# MECKLENBURG COUNTY HEALTH DEPARTMENT

### APPLICATION FOR PERCOLATION TEST

**SUBJECT:** APT #6349 (Brief Road Development Co.)
Lot No. 6, Baxley Lane
11-2-73

SITE DISAPPROVAL REPORT
INDIVIDUAL SEPTIC TANK SYSTEM WITH SUBSURFACE,
SOIL ABSORPTION, EFFLUENT DISCHARGE

7) ACCURATELY DIAGRAM & DIMENSION LOT

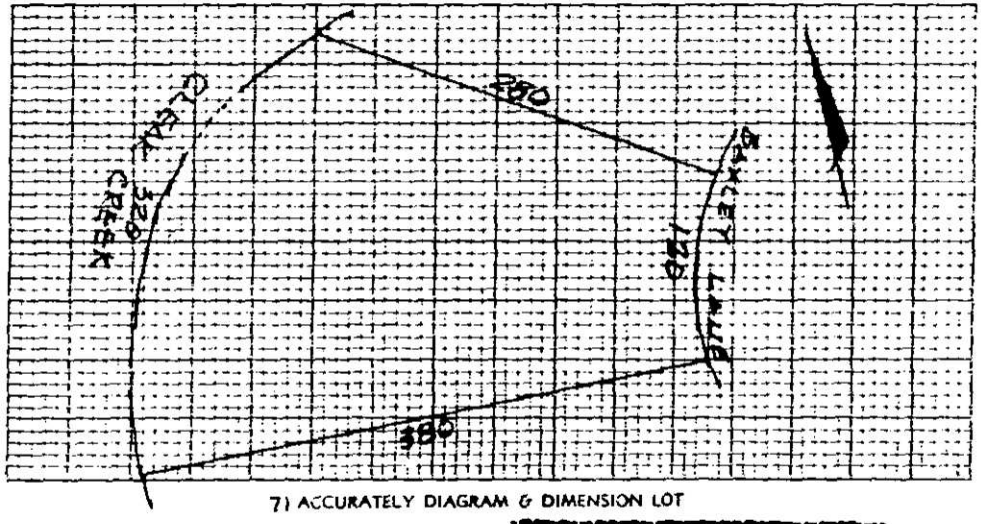
Soils were found to be fill material on the front of the lot (adjacent to Baxley Lane) to a depth of 18 to 36 inches. This fill material overlies an area of alluvial soils. These alluvial soils have a seasonal high water table. This factor results in inadequately slow permeability and percolation rate. The rear portion of the lot is also subject to flooding.

Based on this investigation, the lot is unsuitable for installation of a septic tank system.
